# AIRPORT LAND USE COMMISSION RIVERSIDE COUNTY AGENDA

Thursday 9:00 A.M., April 14, 2016

- 2.1 ZAP1038PS16 – Palm Springs Unified School District (Representative: John Vega) - Environmental Impact Report State Clearinghouse No. 2015031105. Palm Springs Unified School District proposes to replace existing buildings at Agua Caliente Elementary School located at 30-800 San Luis Rey Drive inside San Gabriel Drive Circle in Cathedral City with five new buildings at different areas within the school's existing campus. The project would facilitate an increase in the capacity of the school so as to allow for an enrollment of up to 850 students, specifically including the addition of 120 pre-kindergarten students. (Airport Compatibility Zone D of the Palm Springs International Airport Influence Area). ALUC Staff Planner: Russell Brady at (951) 955-0549, or e-mail at [rbrady@rctlma.org](mailto:rbrady@rctlma.org)

**PROJECT DESCRIPTION:** Palm Springs Unified School District proposes to replace existing buildings at Agua Caliente Elementary School with five new buildings at different areas within the school's existing campus. Outdoor recreation areas would also be provided. The project woul

3/29/2016 1:47:53 PM	TITLE: ALUC DIAGRAM		SHEET REF:
	AGUA CALIENTE ELEMENTARY SCHOOL PALM SPRINGS UNIFIED SCHOOL DISTRICT		DOC. REF:
			CONTR. REF:
	APPL. NO: 04-114748	FILE NO:	DATE: 03/29/16
			JOB NO: 14012-00
624 Broadway, Suite 405 San Diego, California 92101		DRAWING: ALUC-1

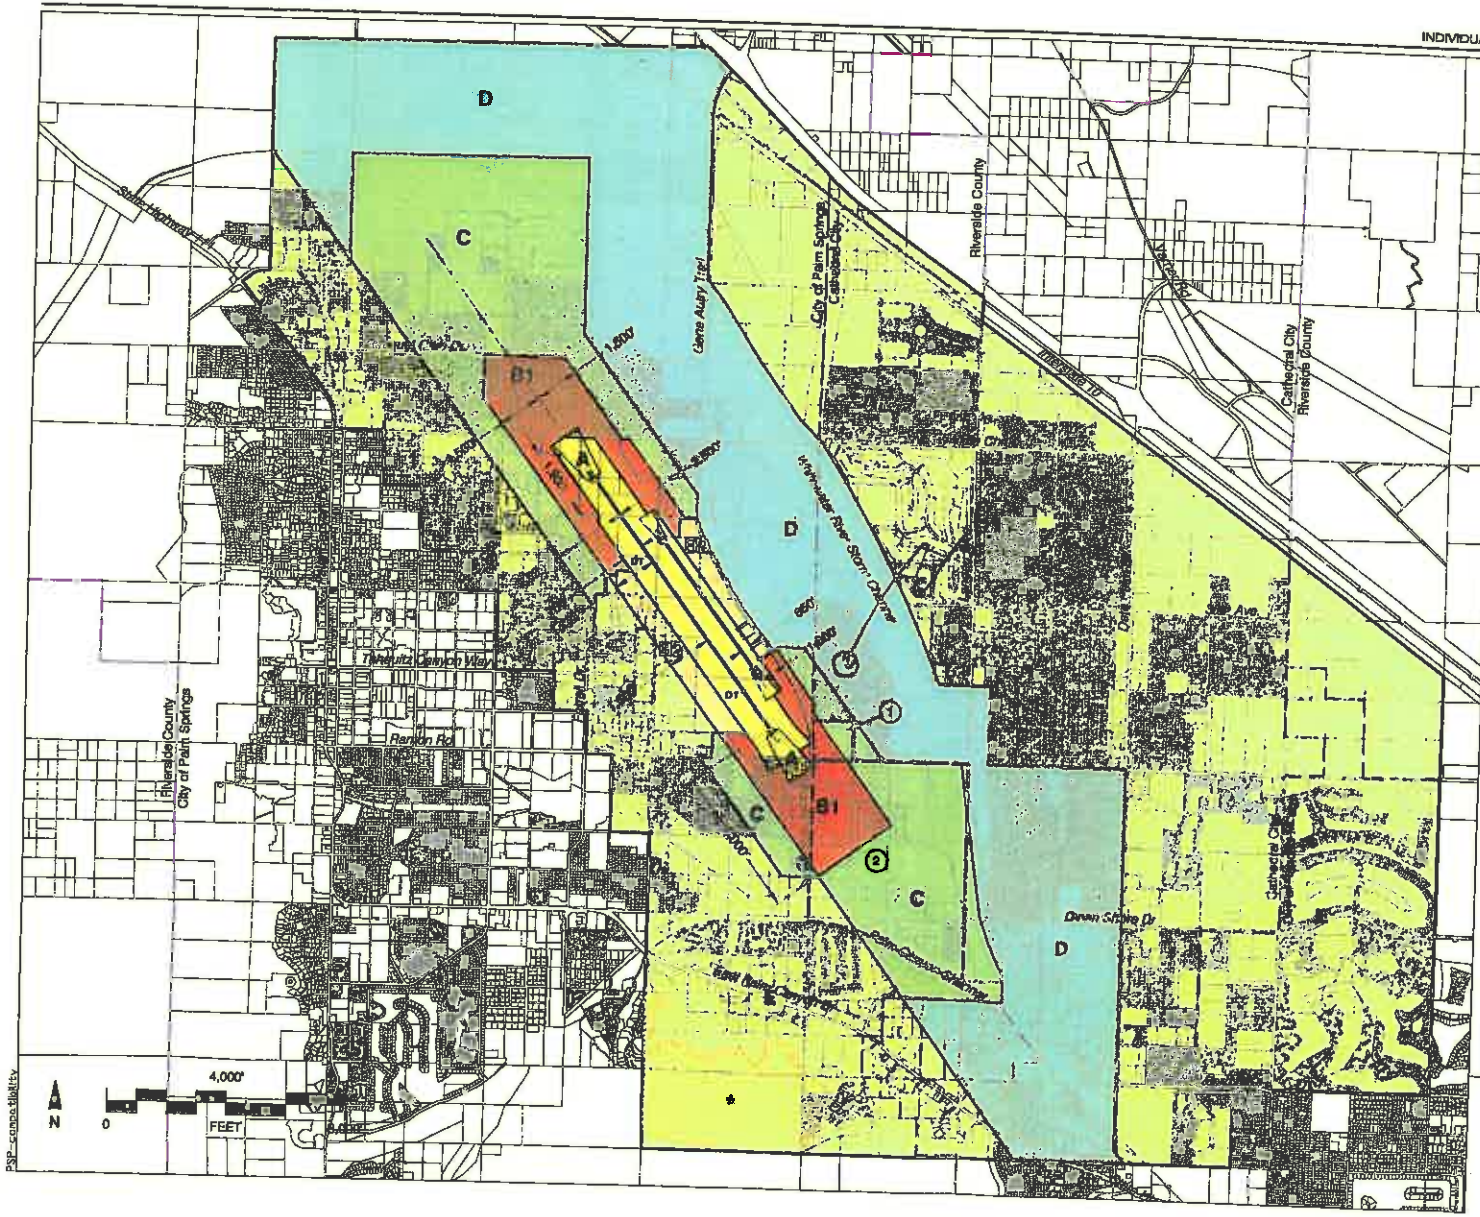
- **The project includes approximately 25% open area. This exceeds the minimum requirements of 10% of Compatibility Zone D. This additional open area to provide potential location for emergency landings may assist in offsetting the risk of an emergency landing on the more intense portions of the site that exceed the intensity criteria for Compatibility Zone D.**

6. The recreation/field areas including a soccer field and baseball field as generally shown in the northern portion of the site titled ~~ALUC Diagram~~~~Overall Site Plan~~, dated ~~3/29/16~~~~10/05/2015~~ and Planting Plan dated 10/05/15 shall be kept free of structures and other major obstacles such as walls, large trees or poles (greater than 4 inches in diameter, measured 4 feet above the ground), and overhead wires excluding those trees shown on the Planting Plan and a backstop/fence for the baseball field. Small trees and shrubs that exceed 4 feet in height and/or thickness of 4 inches may be allowed along the edge of open space
